4328 Brooklyn Ave NE

Recommendation Meeting

SDCI: 3036008-LU

February 28, 2022

Lighting: Lighting Glow Plan (Ground Level)

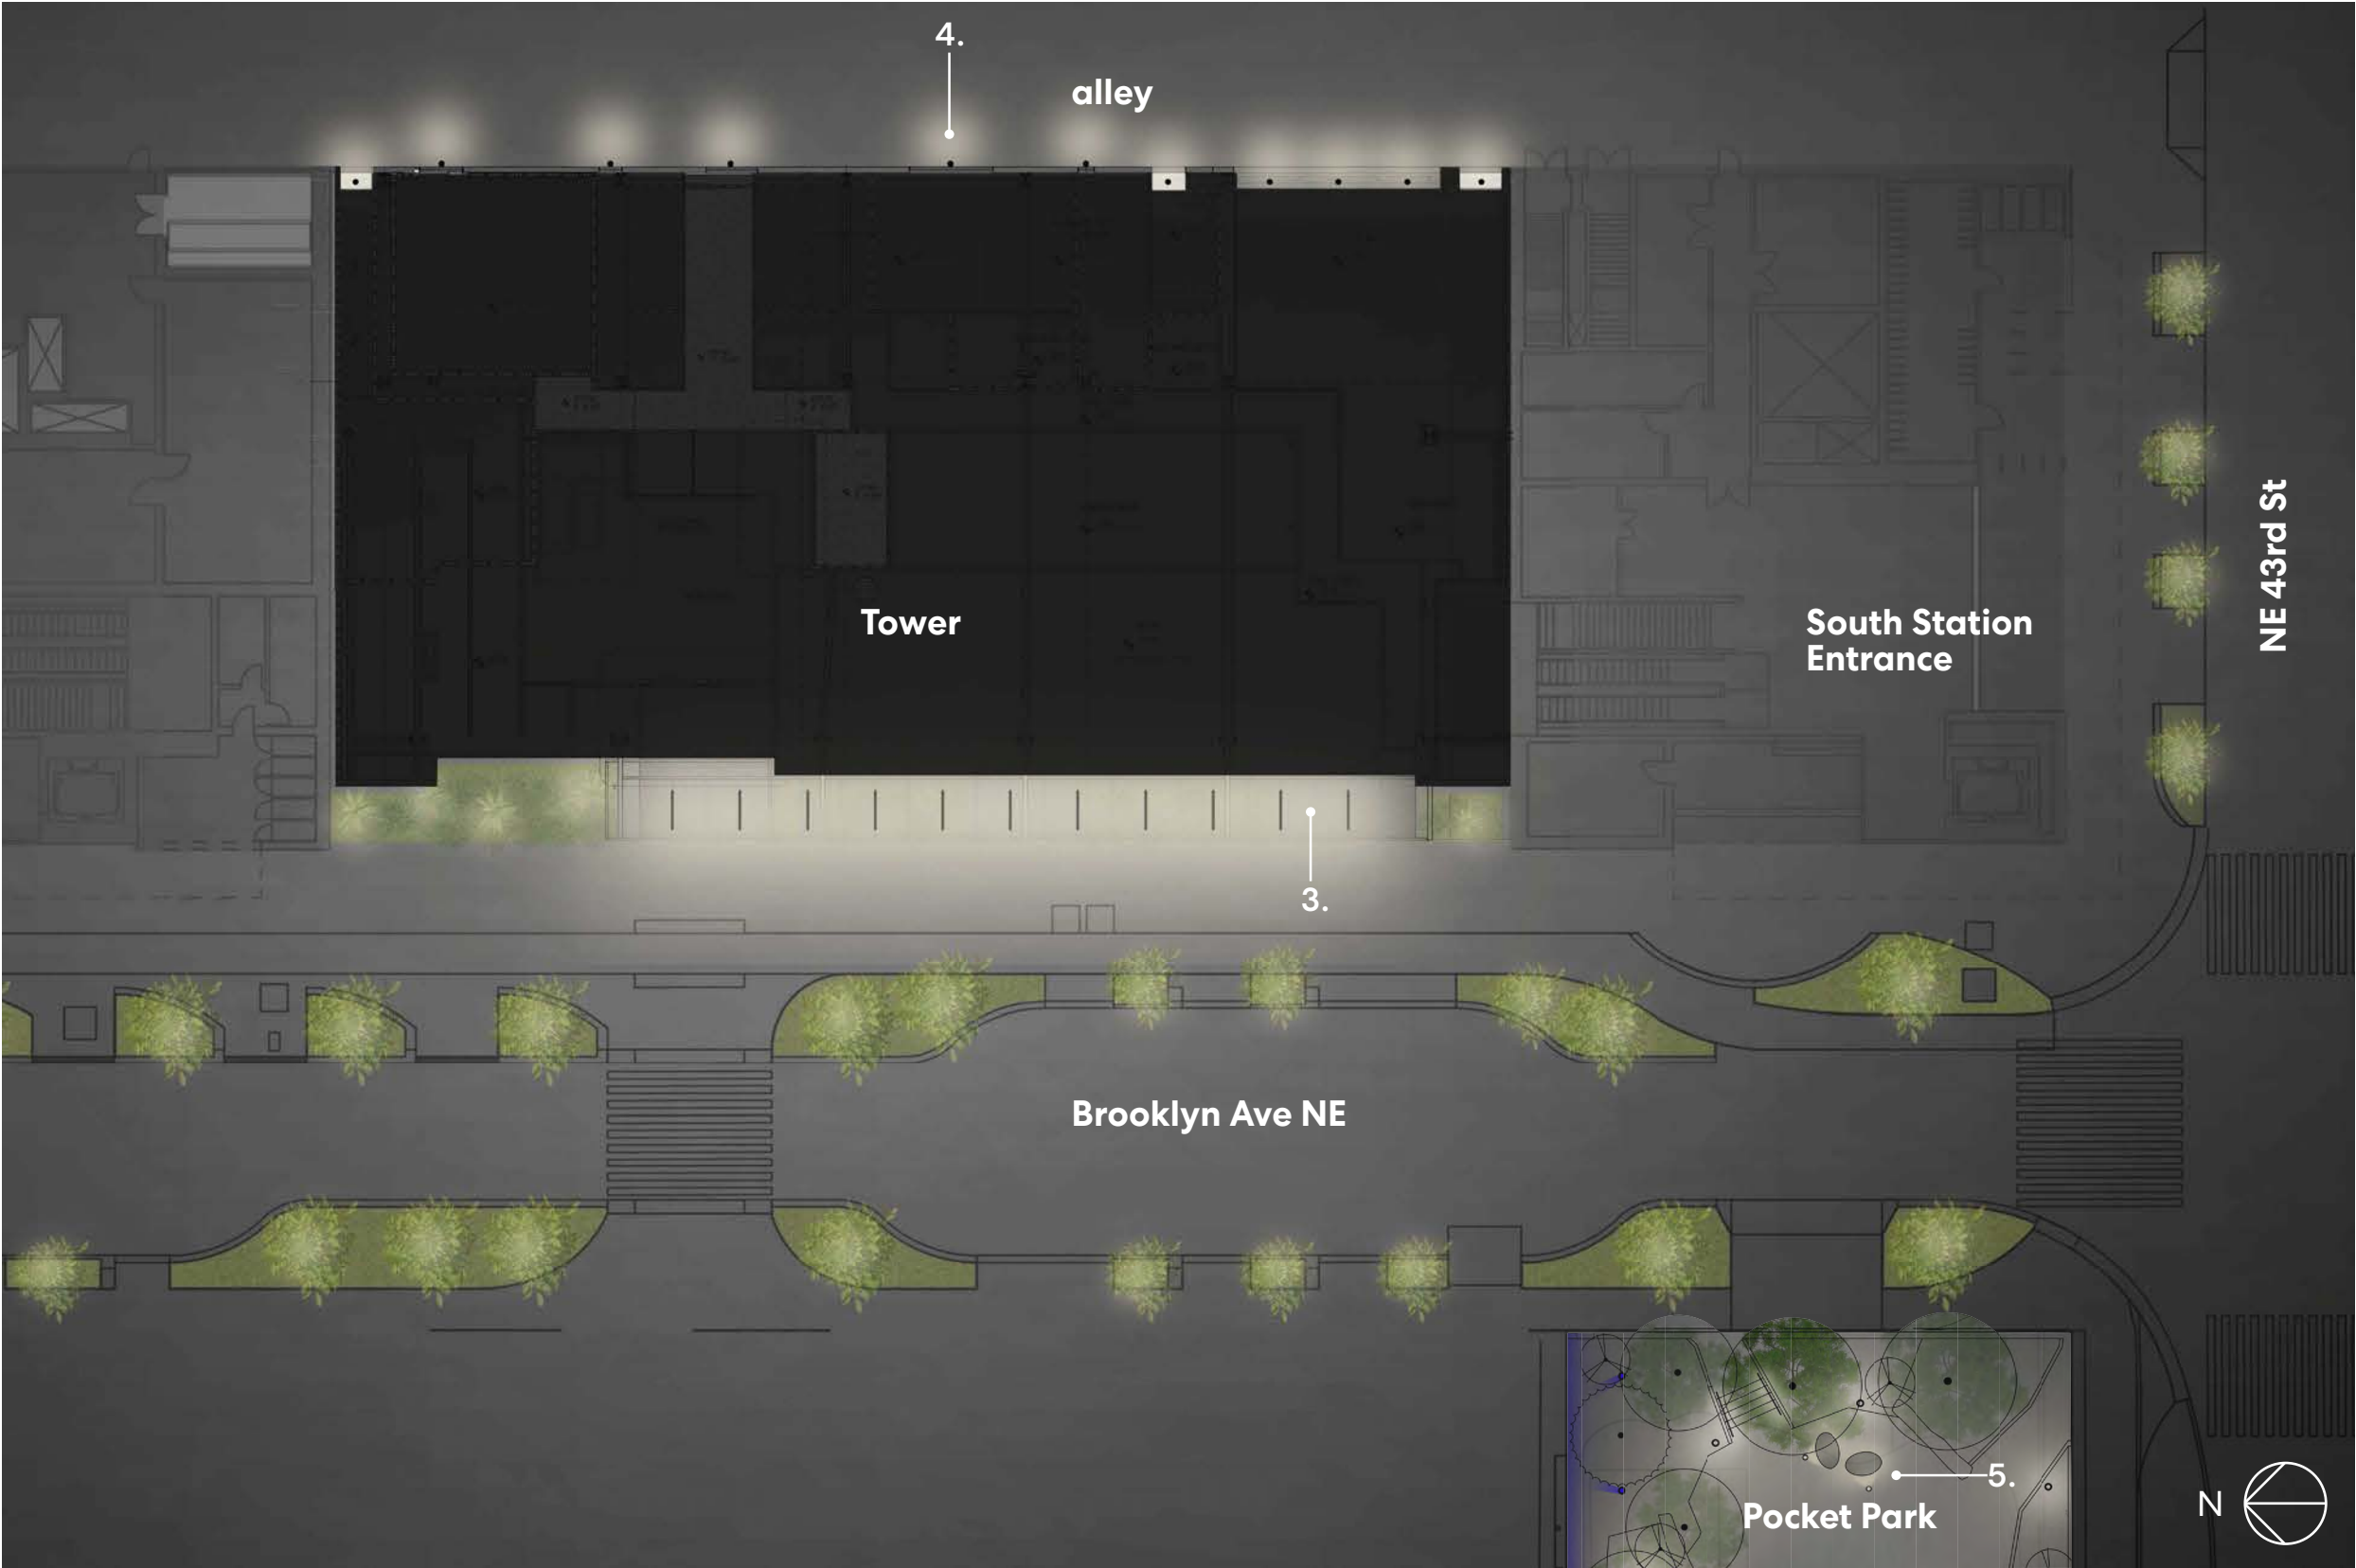
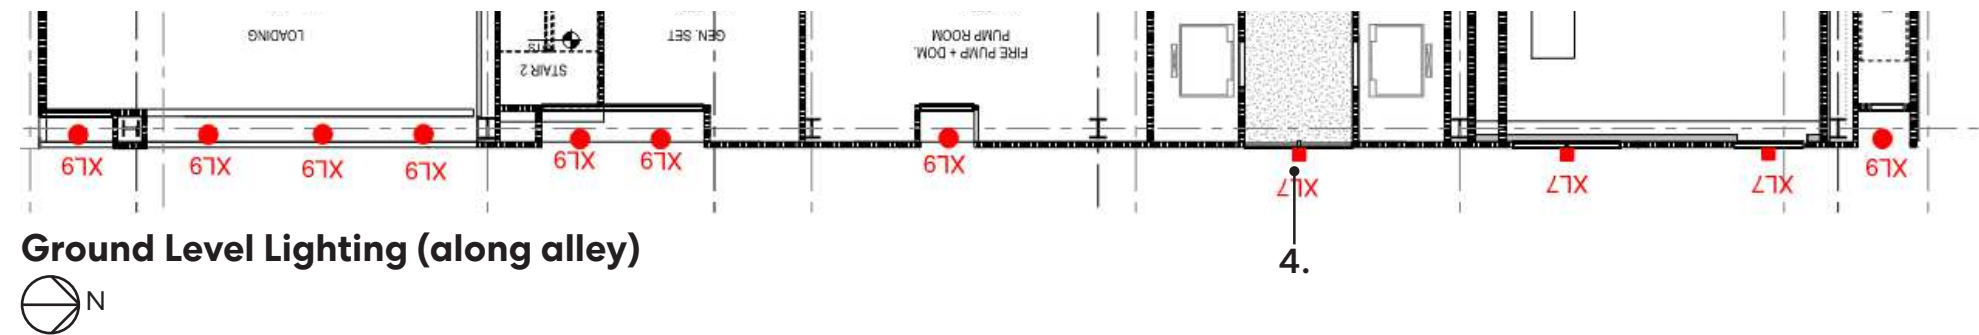
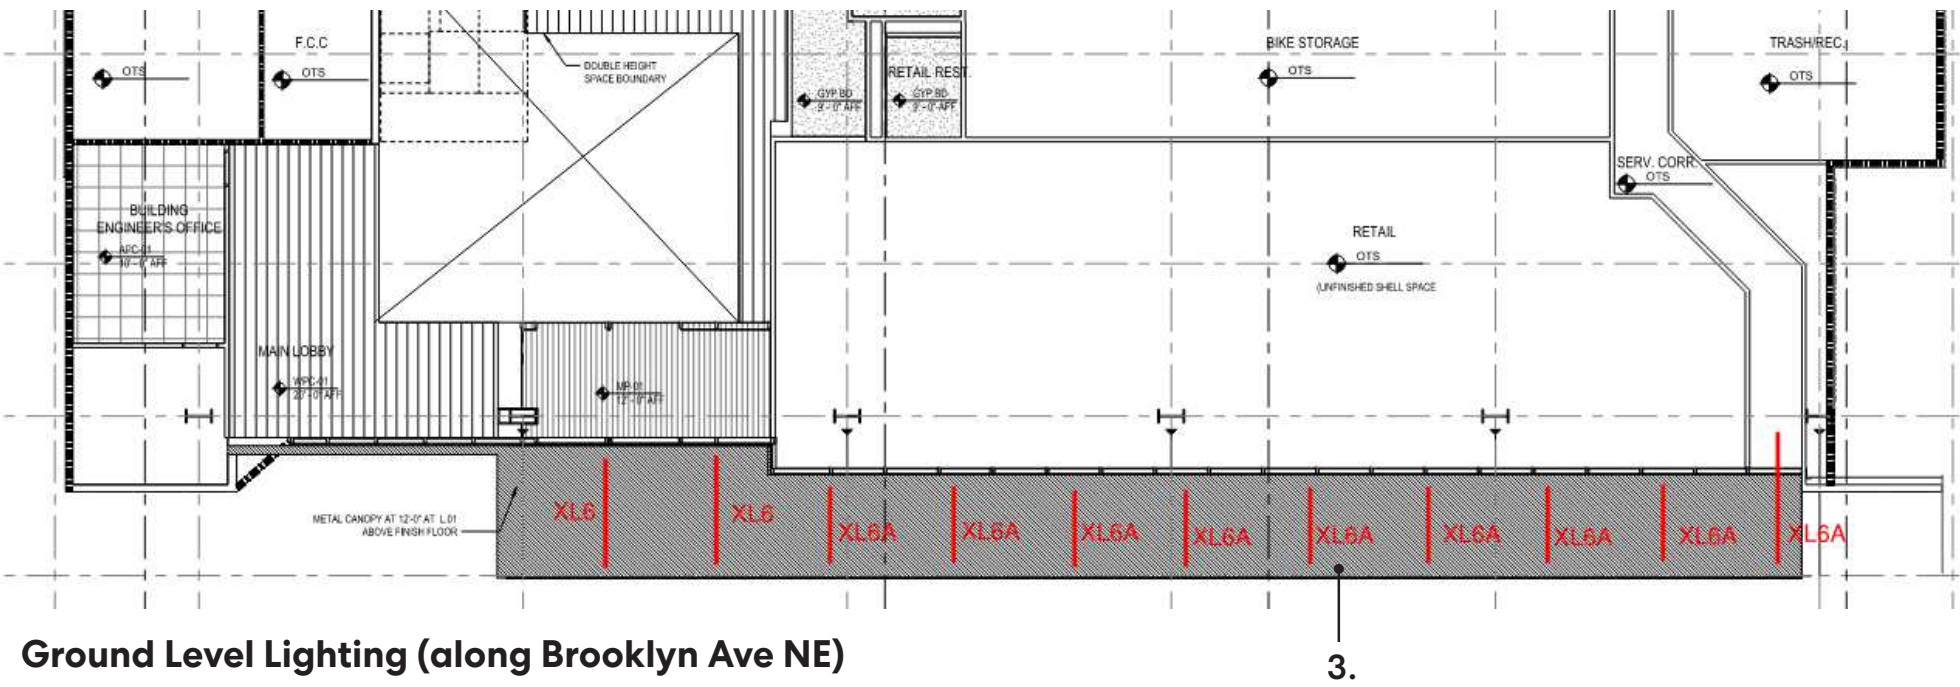
2f) *Study how lighting can be used to highlight the buildings, edges, and streetscape in a thoughtful and dynamic way*

- 1. Linear lighting is integrated into the perimeter of the overhead shade structure to highlight the architectural rooftop expression (PL2-B.2)
- 2. Accent lighting is used to highlight the architectural expression of the tower aperture (PL2-B.2)
- 3. An overhead canopy with integrated lighting creates a well lit and safe walking environment (PL2-B.2)
- 4. Building lighting along the alley creates a well lit and safe walking environment (PL2-B.2)
- 5. The pocket park will be well lit for pedestrian and user safety, will have accent lighting to highlight landscaped areas and trees, and to showcase a potential public art installation. Specialty lighting is also being considered to animate the blank south wall of the UW Tower annex (PL2-B.2)
